UNITED STATES PATENT AND TRADEMARK OFFICE

| APPLICATION NO. | FILING DATE | FIRST NAMED INVENTOR | ATTORNEY DOCKET NO. | CONFIRMATION NO. |
|-----------------|-------------|----------------------|---------------------|------------------|
| 10/609,421 | 07/01/2003 | Hiroshi Ohkura | 03500.014730.1 | 9477 |

DETAILED ACTION

Figure I: Illustration of interpretations of claim language

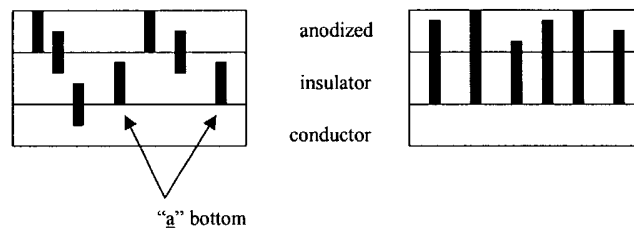
Specifically, the Examiner notes that the "columnar parts" are formed extending into/through both the insulator and anodized layer and are not "separate" columns in each layer. Applicants are recommended to reword the claim to better clarify that the insulator and the anodized layer have columnar parts *extending at least into both layers*, wherein a bottom of the columnar parts contacts the electrical conductor. See Figure I.

10. Claims 11 – 15 are rejected under 35 U.S.C. 112, first paragraph, because the specification, while being enabling for columnar parts which are coextensive through the insulator and anodized layer (*rightmost illustration in Figure 1 above*), does not reasonably provide enablement for columnar parts which are separate from each other (*leftmost illustration in Figure 1 above*). The specification does not enable any person skilled in the art to which it pertains, or with which it is most nearly connected, to make the invention commensurate in scope with these claims. This rejection can be overcome by amending the claim as suggested in Paragraph 4, above.
